AXIS P3245-VE/-LVE  
outdoor mounting bracket

AXIS P3225-VE/-LVE MkII  
outdoor mounting bracket

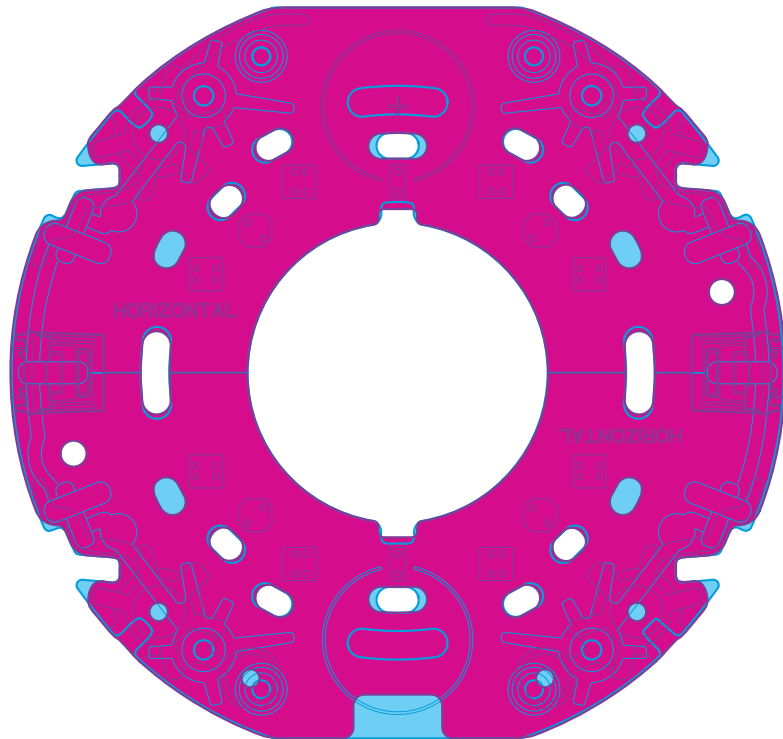
- > To support both horizontally and vertically mounted double gang boxes as well as more Axis accessories, four new holes were added.
- > To preserve robustness, two holes were removed and 12 holes were made slightly smaller.
- > To simplify the installation, four mounting screws were replaced by two clips.
- > Together with the AXIS Conduit Adapters, all new AXIS P32 and AXIS M32 cameras support both 1/2" (M20) and 3/4" (M25) conduits.
- > To synchronize indoor and outdoor accessories, screw pillars and towers were moved to the same positions as the indoor bracket. The brackets of all new AXIS P32 (indoor and outdoor) and AXIS M32 cameras now have the same footprint.
